VISTA RIDGE

Development Plan

Vista Ridge General Development Plan Minor Amendment No. 1

VISTA RIDGE DEVELOPMENT PLAN AMENDMENT No. 3

REVISION BLOCK

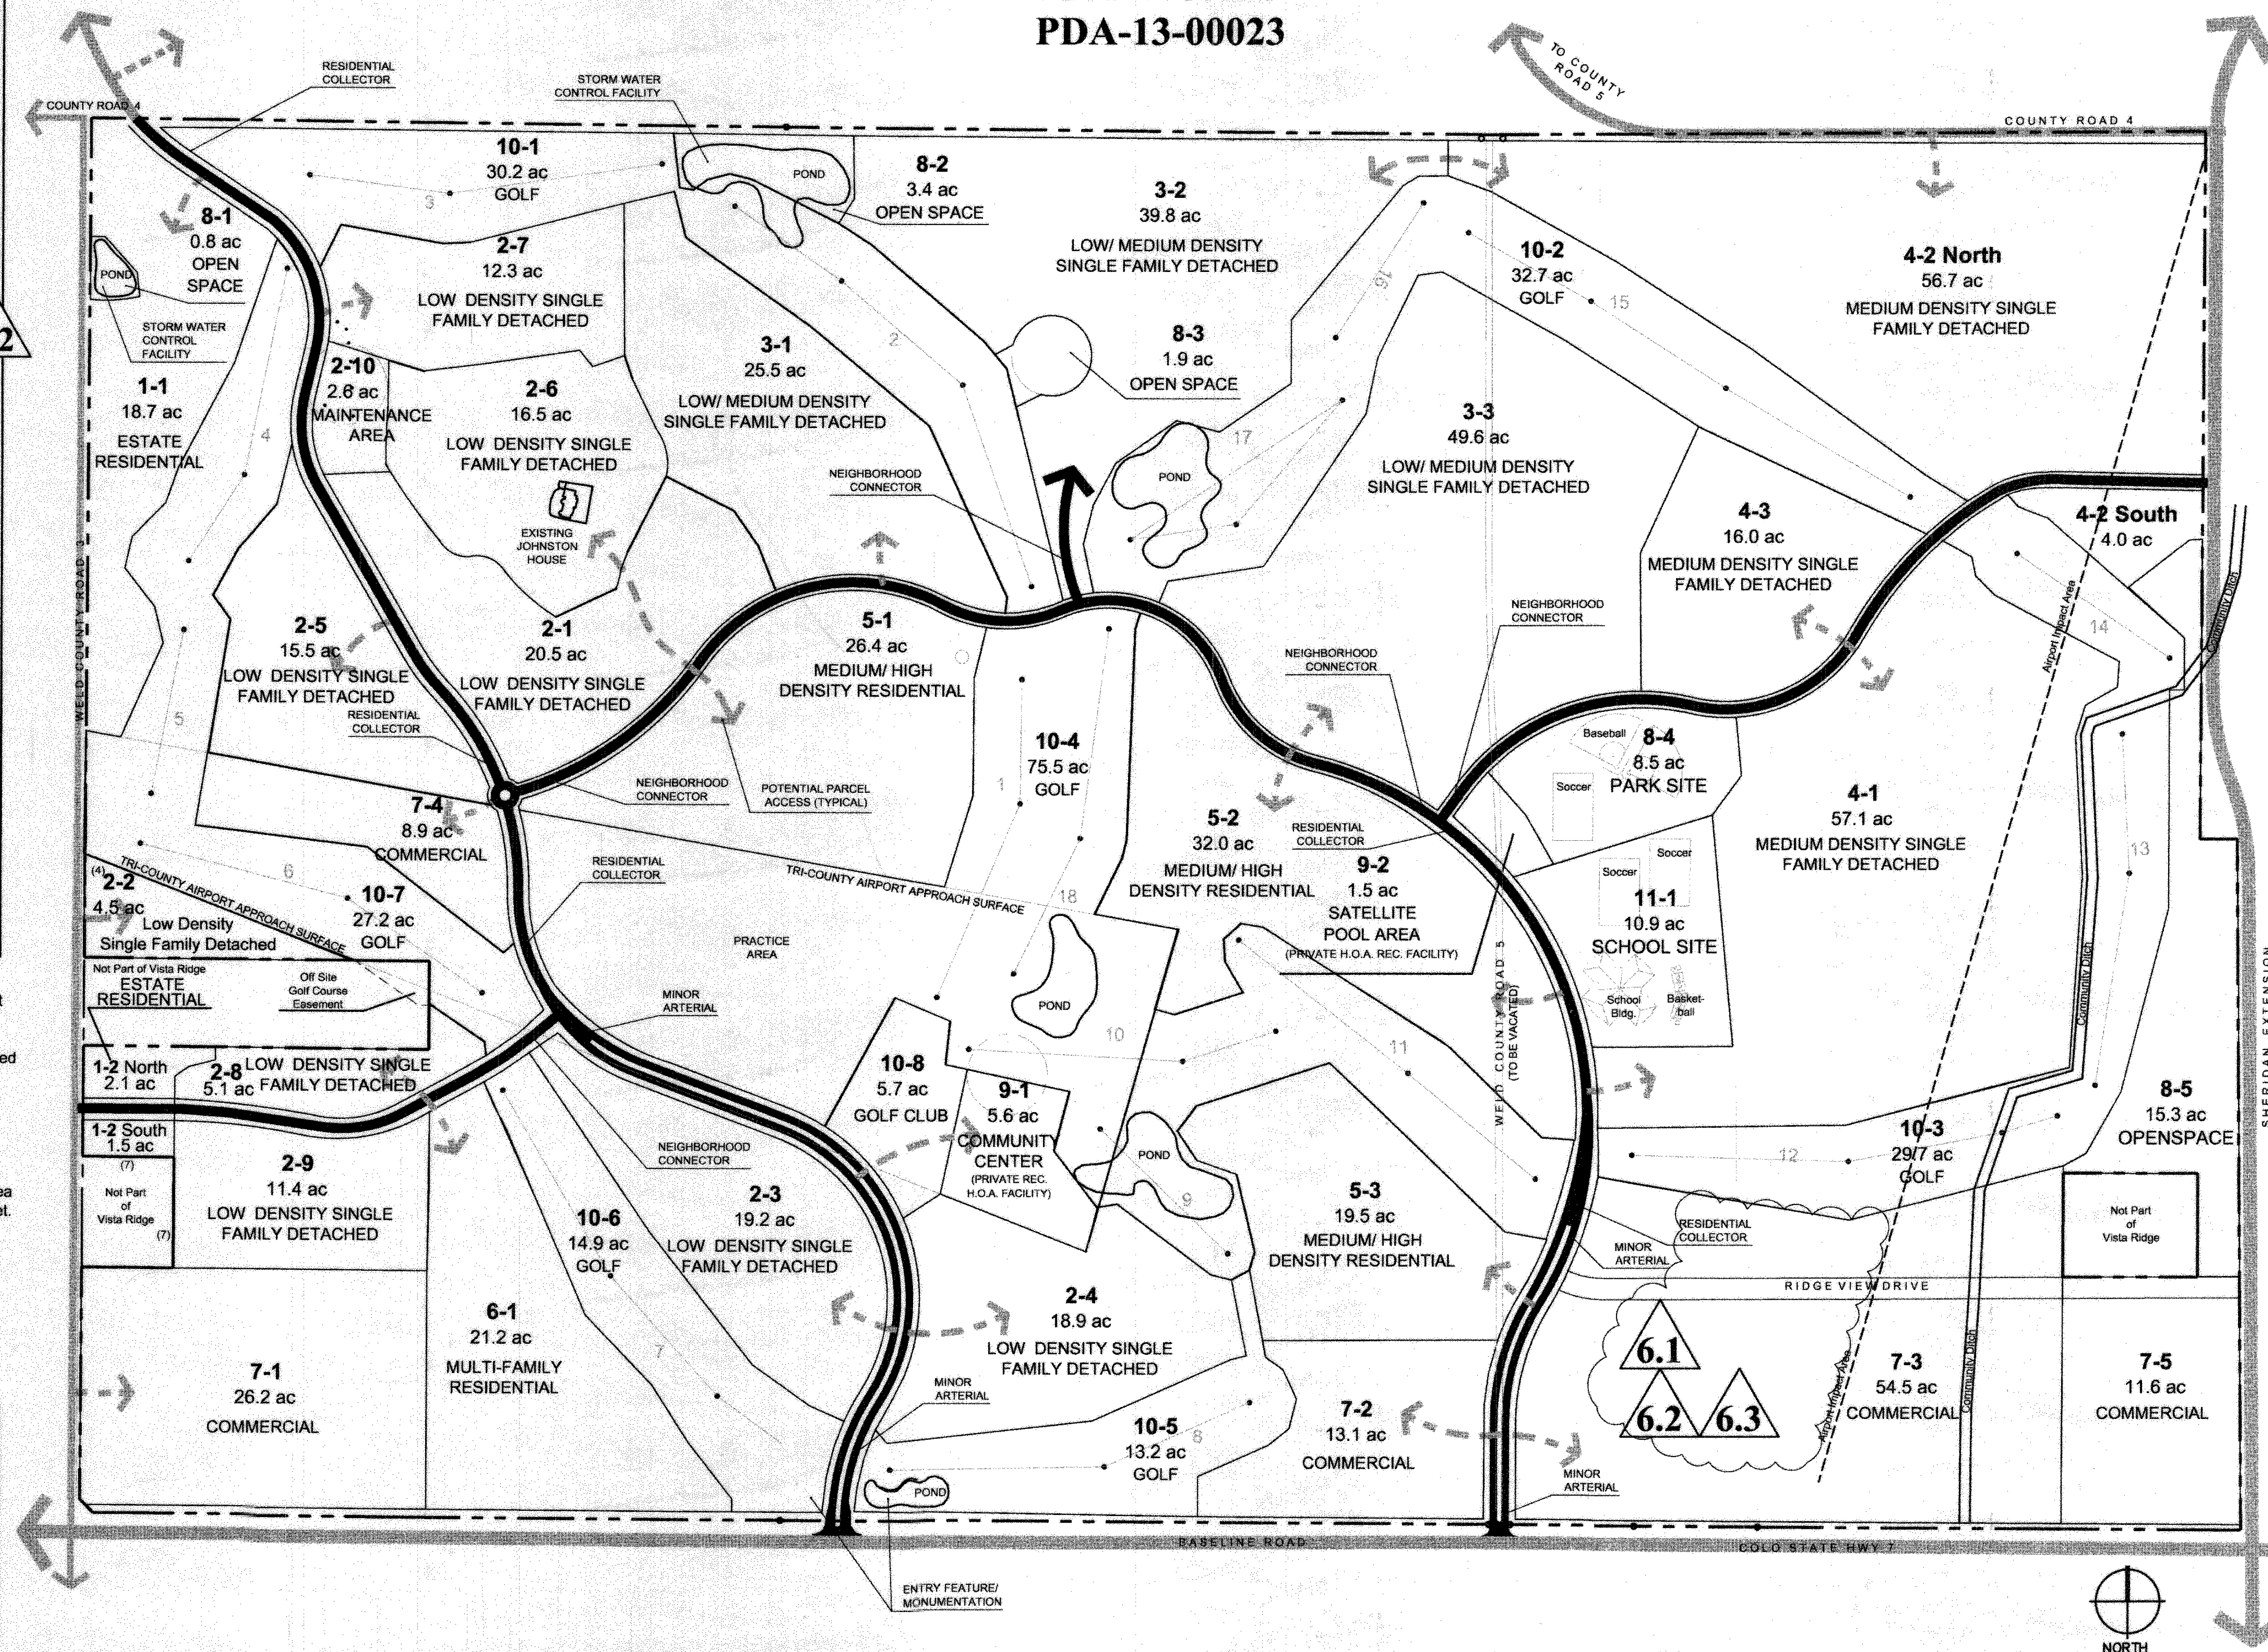
- 6.1 - Added Medium/High Residential, High Density Residential and Multi-family Residential Uses as a Permitted Use to Planning Area 7-3 in two areas.
- 6.2 - Added 200 dwelling units to Planning Area 7-3.
- 6.3 - Medium/High Residential setbacks modified to Planning Area 7-3.
- 4 - Single Family Detached setbacks modified to Planning Area 7-3.

REVISION BLOCK

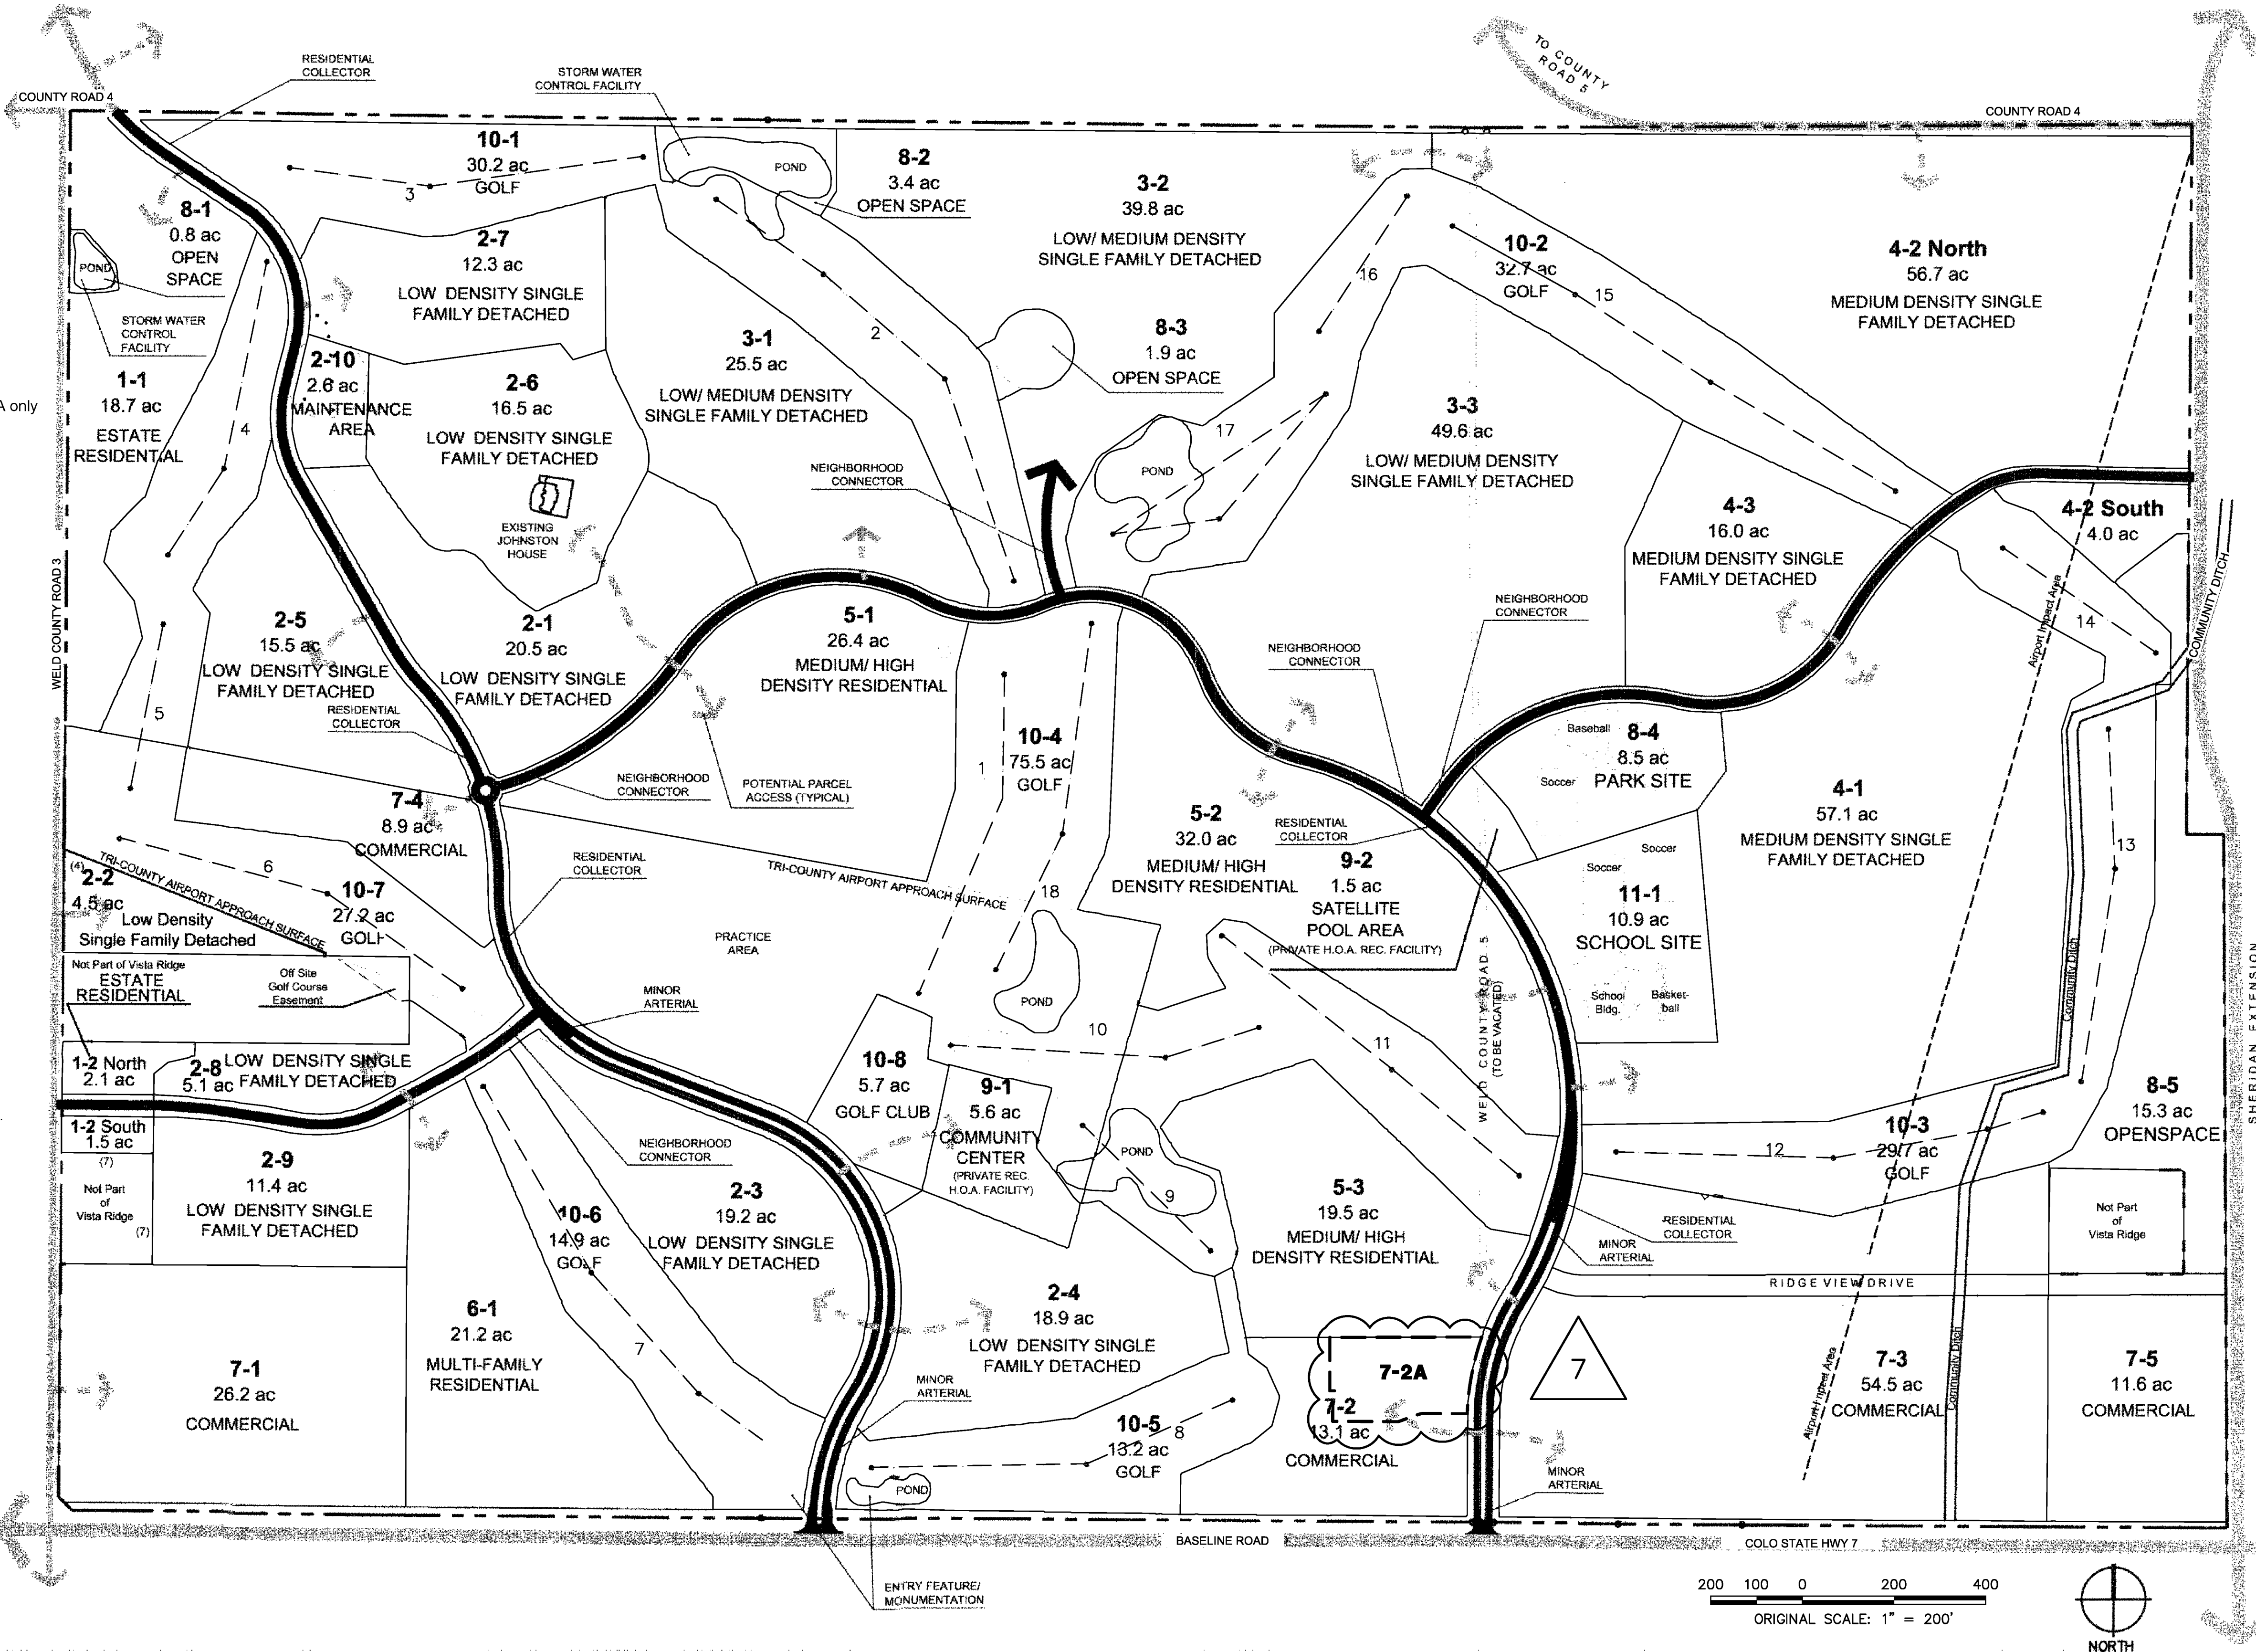
- 1- Added uses to Planning Area 7-2A in one location.
- 2- Described development standards for proposed Planning Area 7-2A.
